DODGE 48RE VALVEBODY HYDRAULIC DIFFERENCES

Figure 1

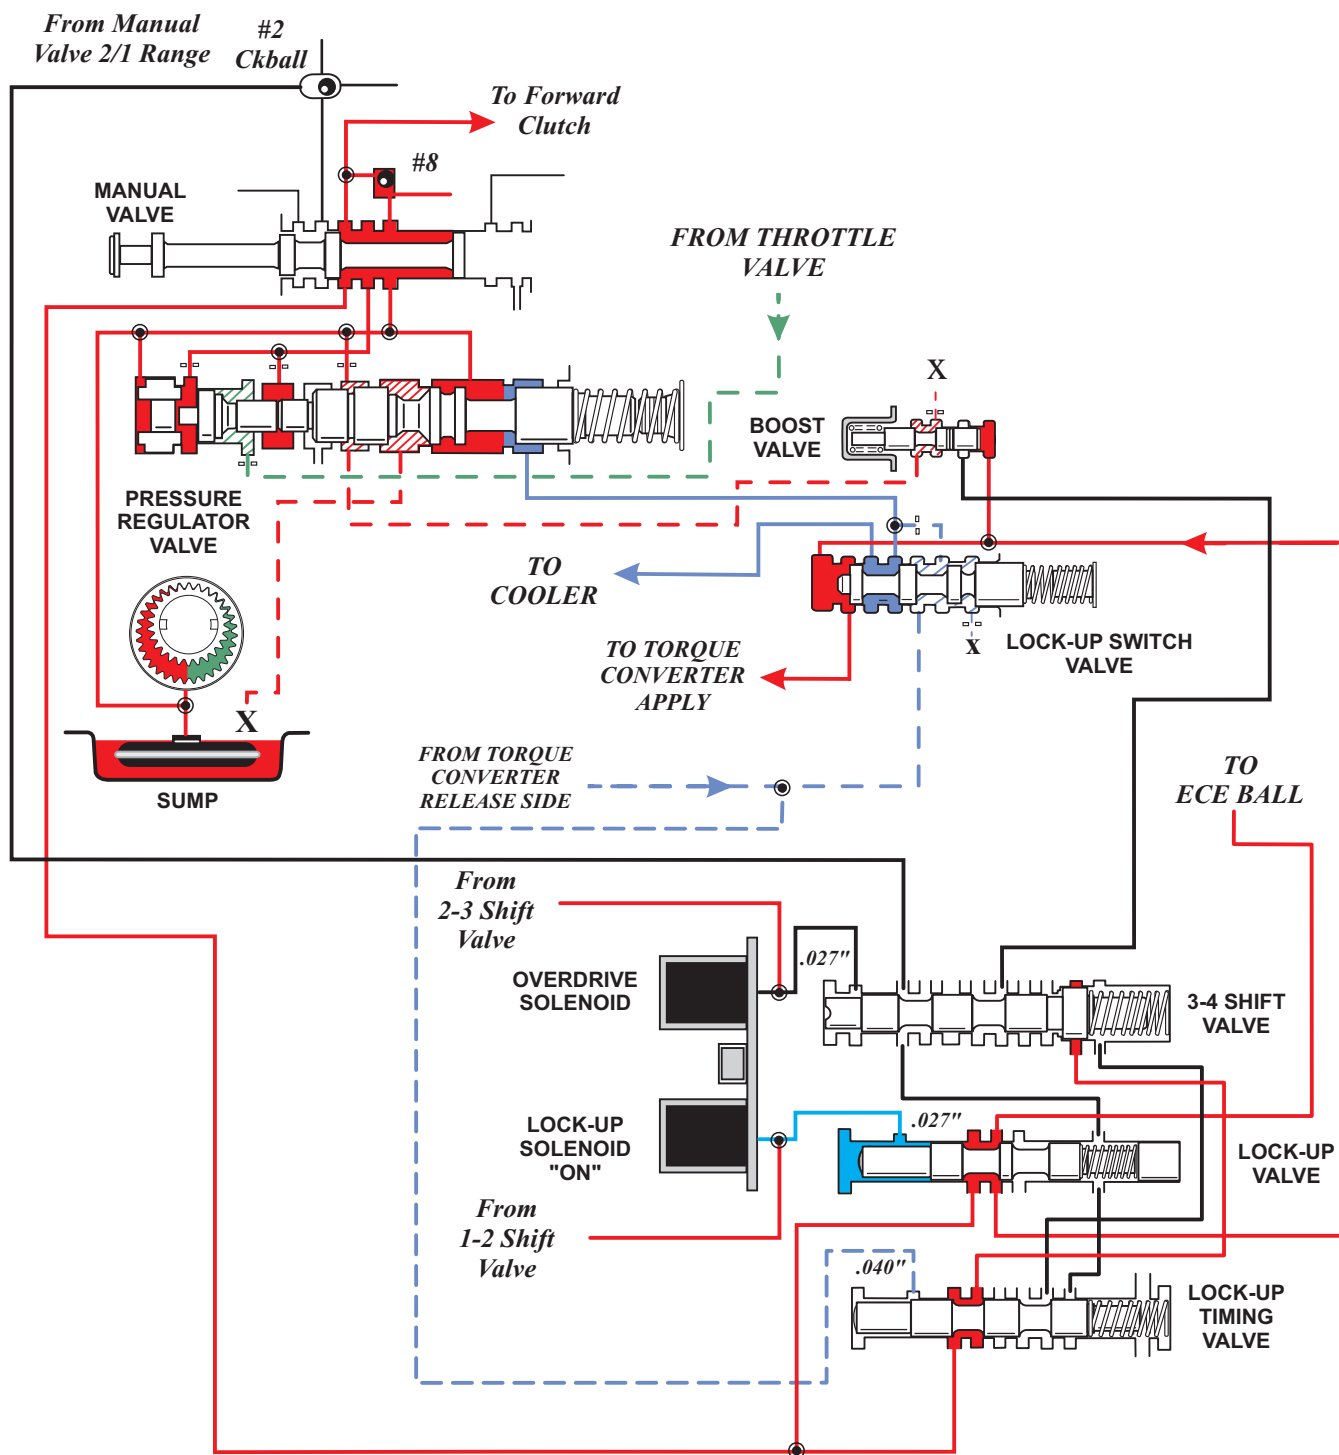
REASON: The reason for the change in the Torque Converter Control Circuit is so that TCC engagement will be possible in the Manual 2 and Manual 1 position, providing better pulling capacity at lower engine rpm. The TCC Solenoid is now fed Forward Clutch pressure instead of the previous design, that was fed from the 1-2 shift valve. This now makes it possible to have TCC in 1st gear. Refer to Figures 1 and 2 for a partial hydraulic circuit diagram of the TCC circuit.

Note: The number 2 Checkball, on 46 and 47RE, is used for a 3-2 manual downshift and for TCC cancel in Manual 2 and Manual 1 ranges, by applying line pressure from the Manual valve to the spring side of the Lock-up and 3-4 Shift Valve, and second land of the Lock-up Timing Valve to Prevent application.

46RE/ 47RE MAIN VALVE BODY AND TRANSFER PLATE "UPPERSIDE"

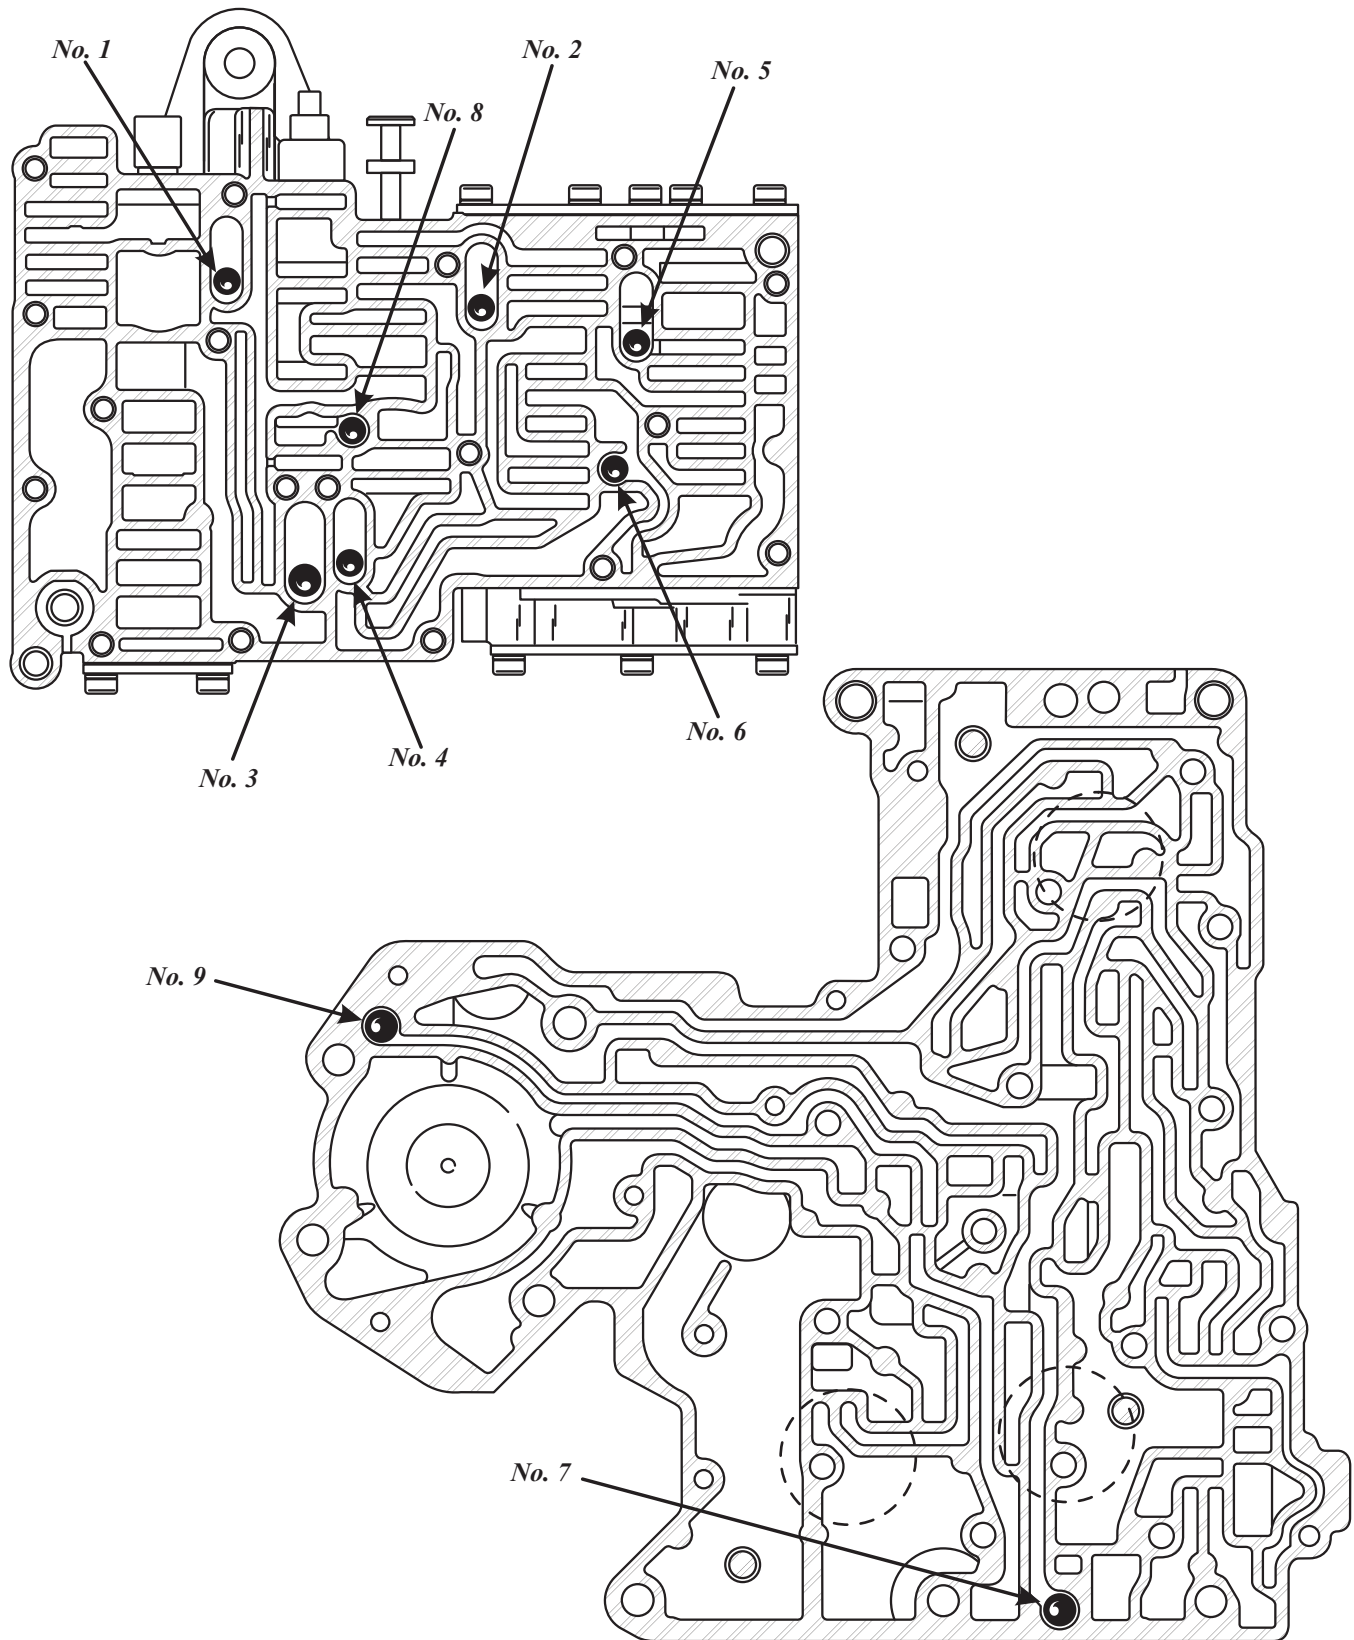
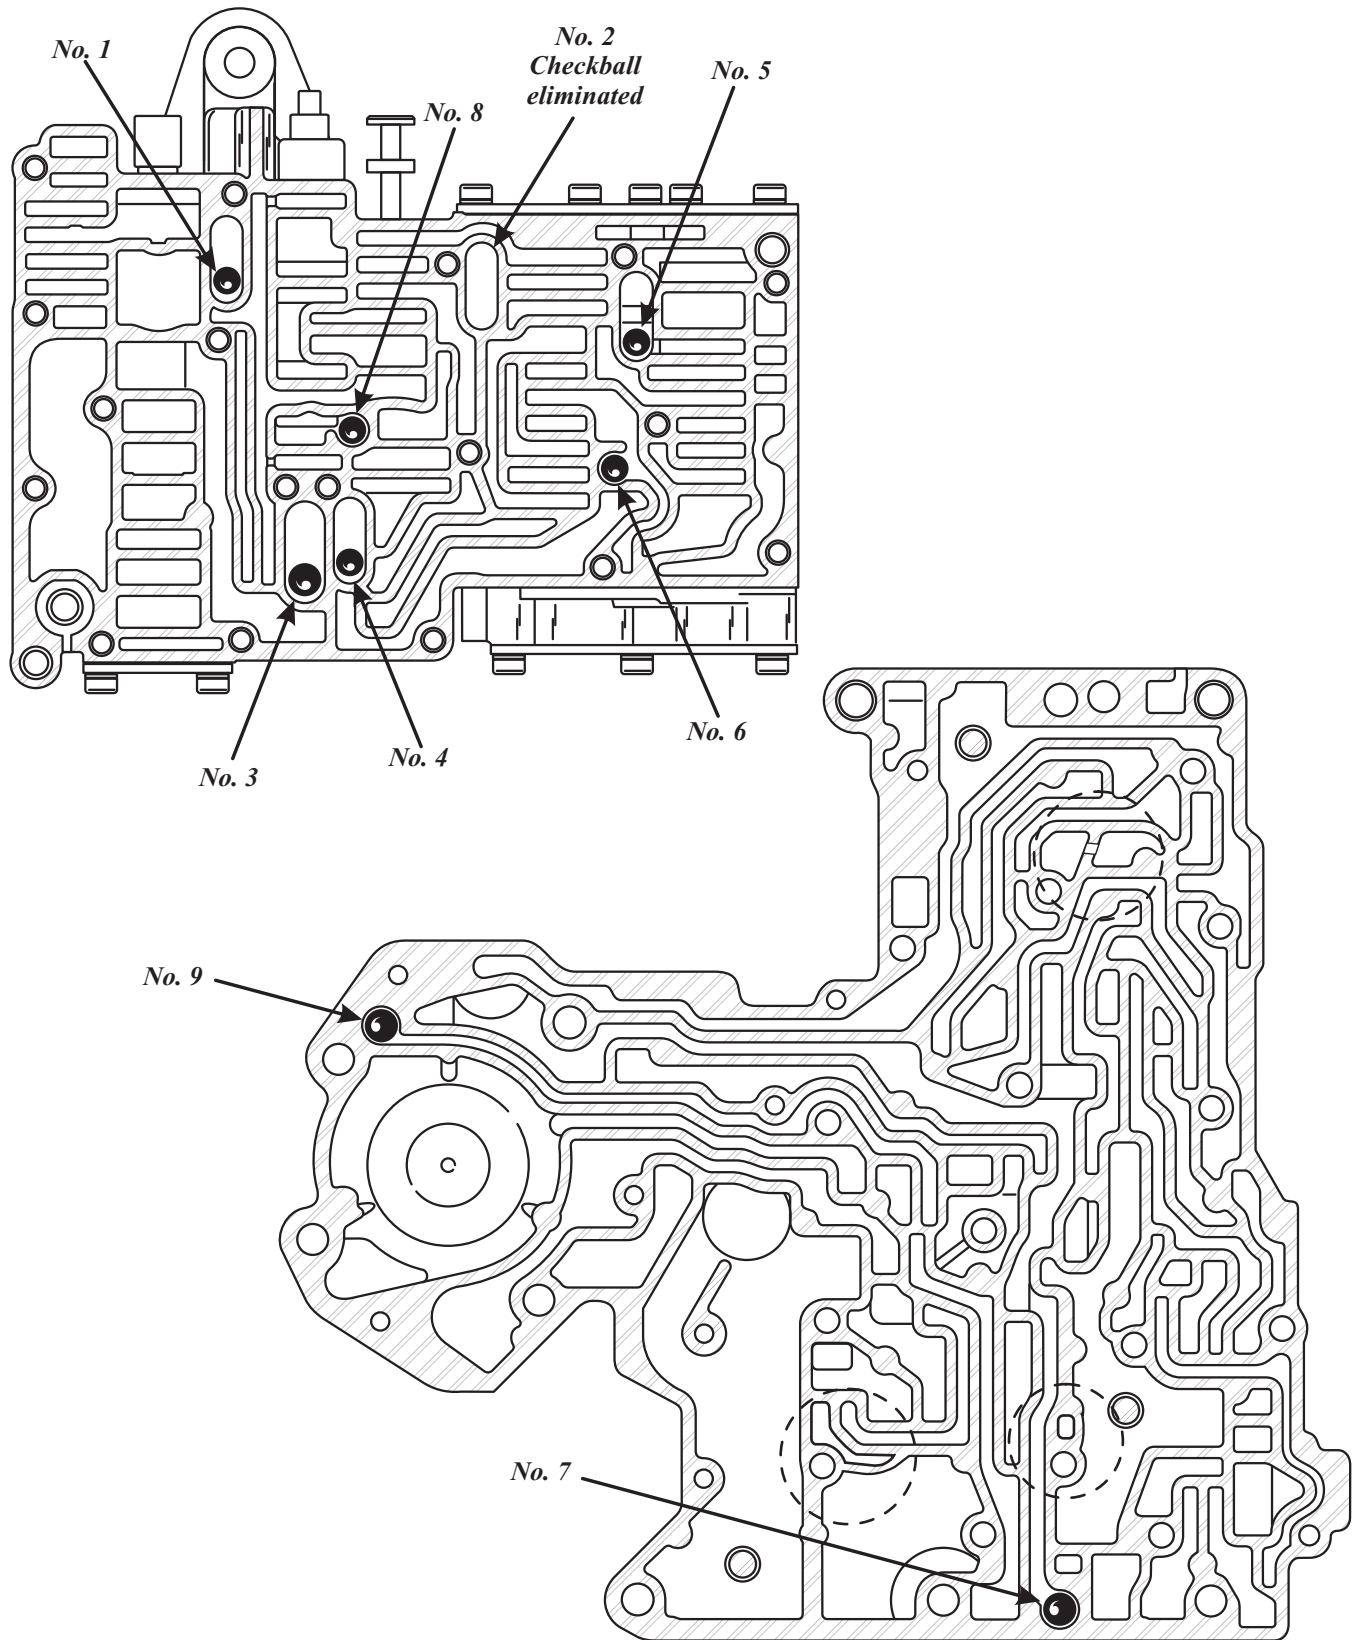
Refer to Figure 3 for a view of the previous design 46RE/47RE Main Valvebody and Upper Transfer Plate and checkball locations. There is also dotted circles around the areas that changed in the 48RE.

Refer to Figure 6 for a view of the new design 48RE Main Valvebody and Upper Transfer Plate and checkball locations, notice the elimination of the Number 2 checkball. There is also dotted circles around the areas that changed in the 48RE.

46RE /47RE MAIN SPACER PLATE

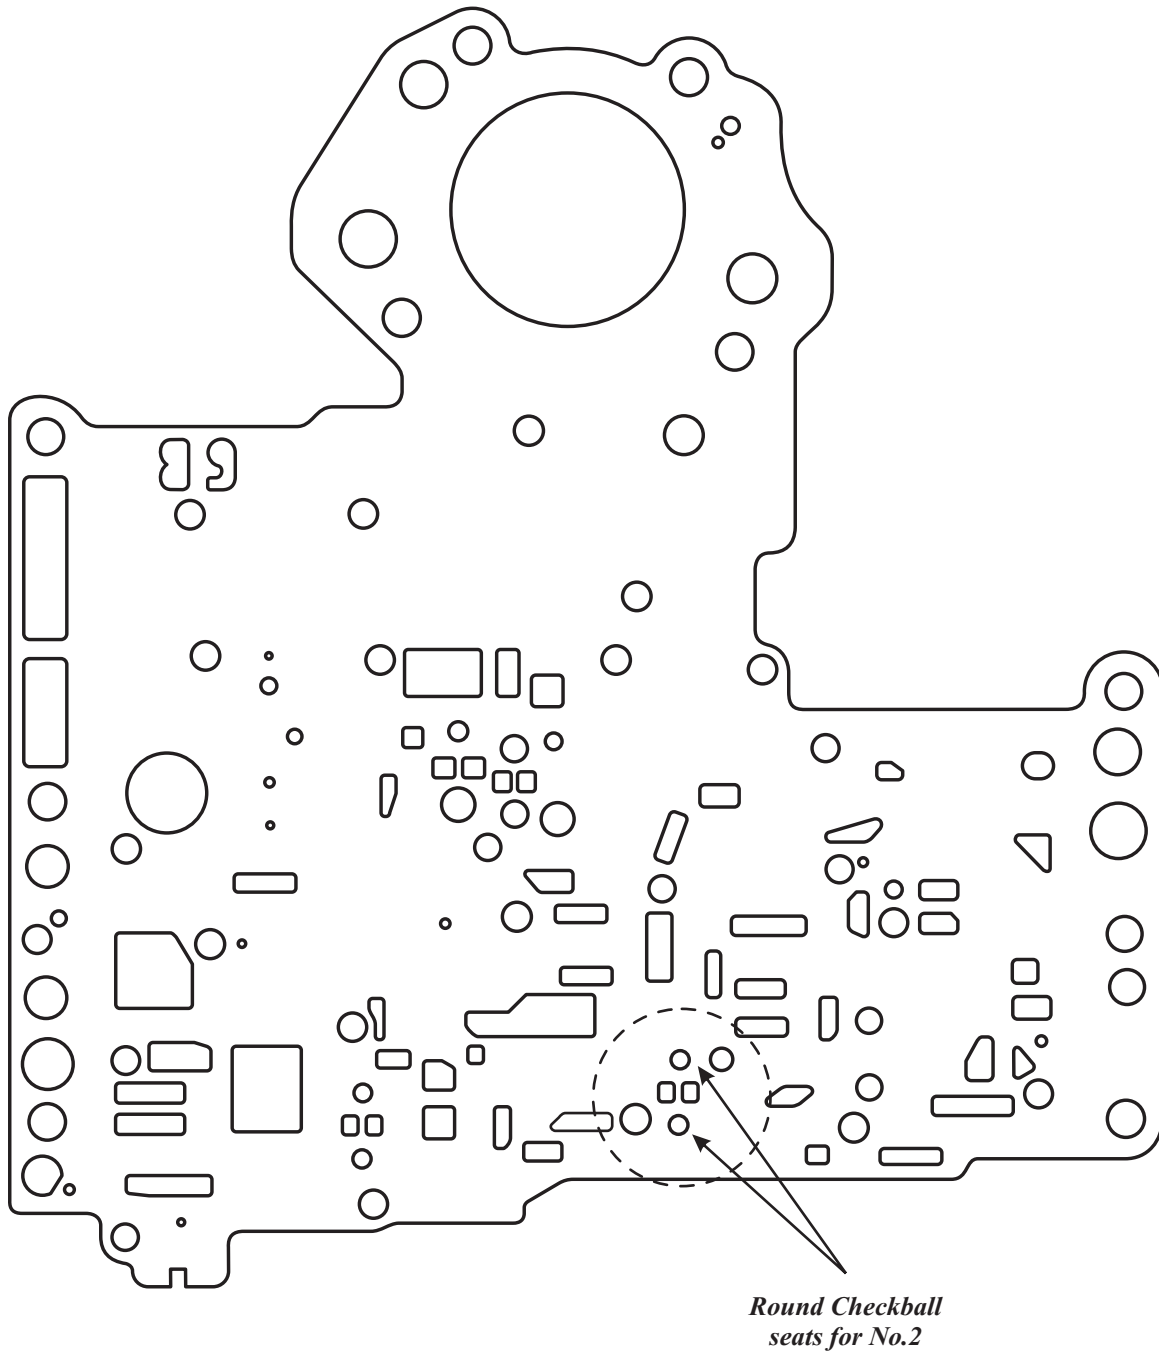
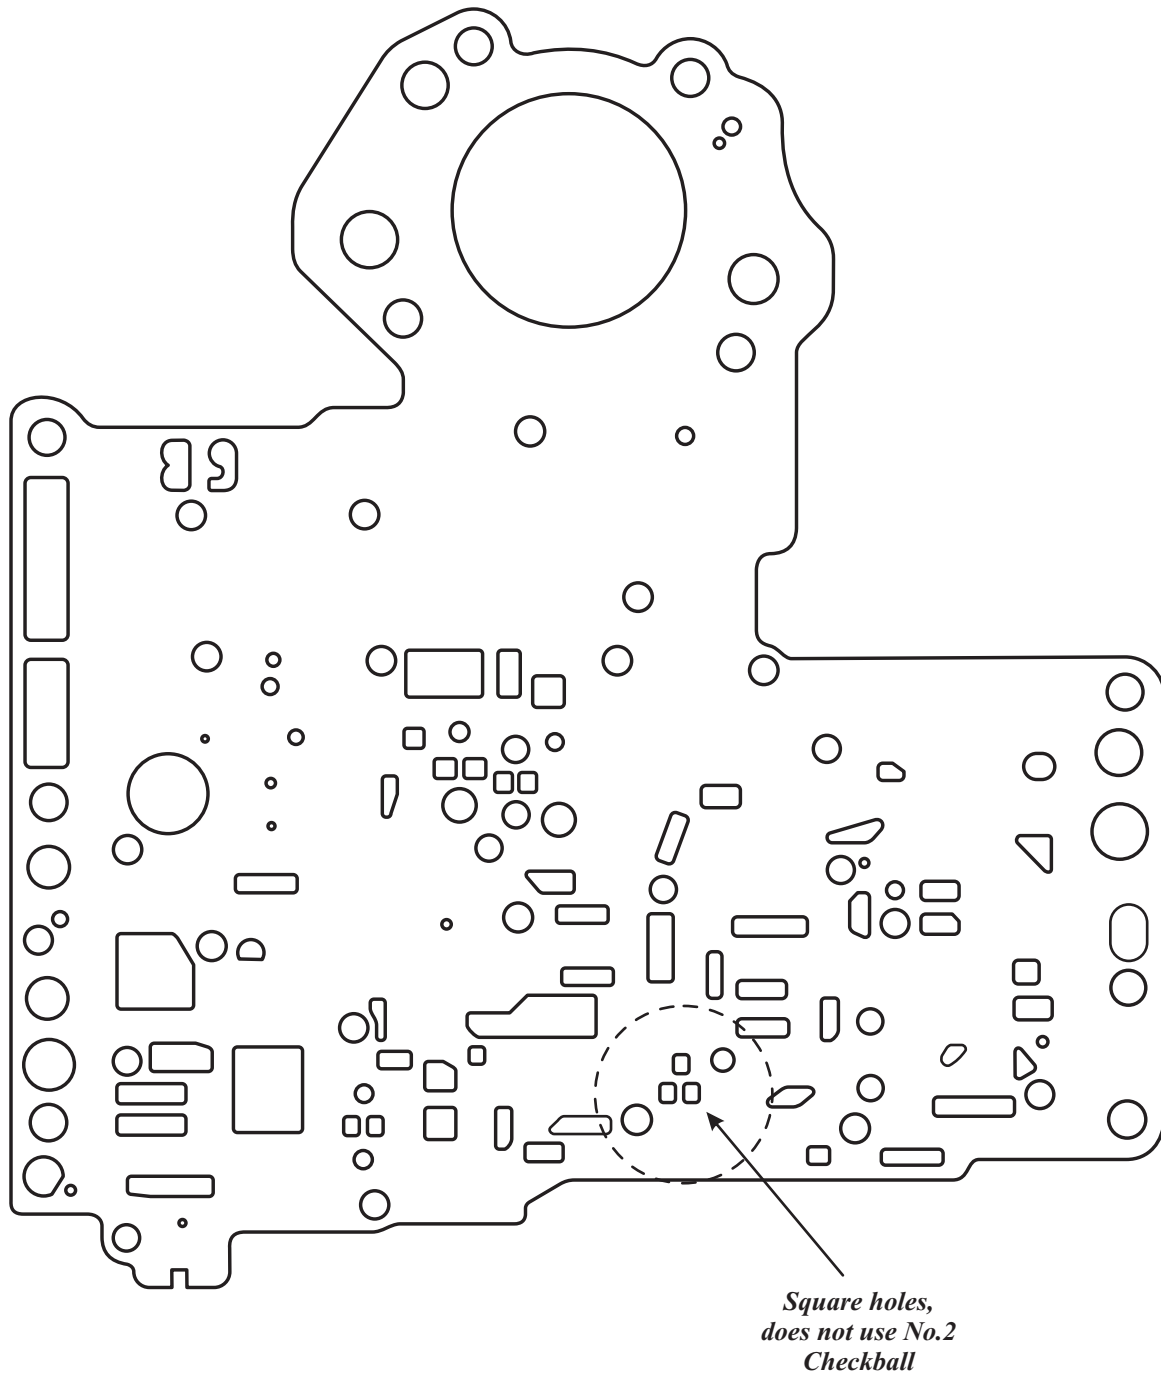
Refer to Figure 4 for a view of the Main Spacer Plate on the 46RE/47RE, and the hole configuration for the Number 2 checkball.

Refer to Figure 7 for a view of the Main Spacer Plate on the 48RE, and the hole configuration for where the Number 2 checkball used to be. Notice there are only 3 holes, which are square, when compared to the previous plate in Figure 4.
